APPLICATION NO.	FILING DATE	FIRST NAMED INVENTOR	ATTORNEY DOCKET NO.	CONFIRMATION NO.
10/055,582	01/23/2002	Dennis P. Silver	11899	7015

KOVACS, ARPAD F

Office Action Summary

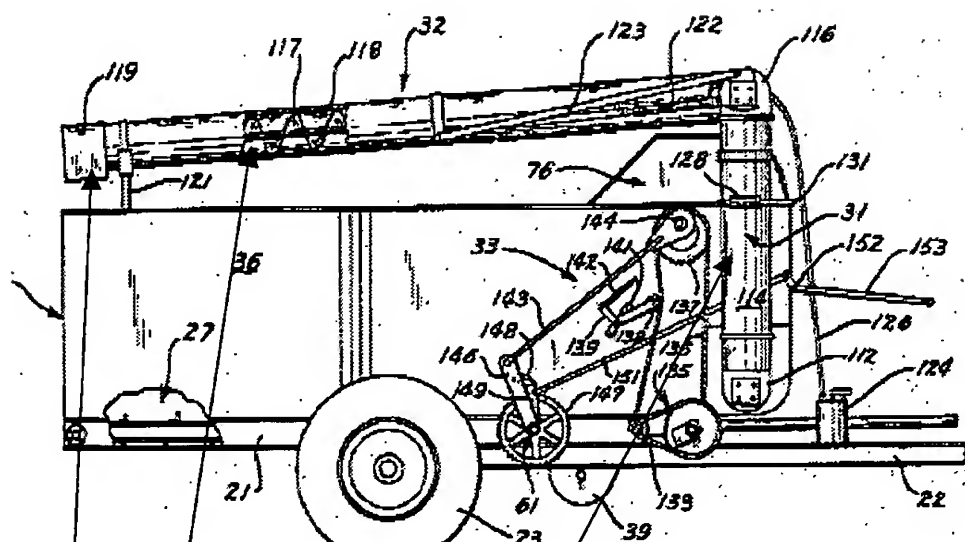
3. Claims 1-2, 4-6, 8, 10-11, 13, 15-20 are rejected under 35 U.S.C. 103(a) as being unpatentable over Hansen (3286862), in view of Mooney et al (6119847). Hansen discloses the claimed invention as also shown for clarity in the marked drawings below, except for the foldable unloading auger as claimed.

Outfeed auger section

Substantially vertical infeed auger section

Spout for preventing spilling
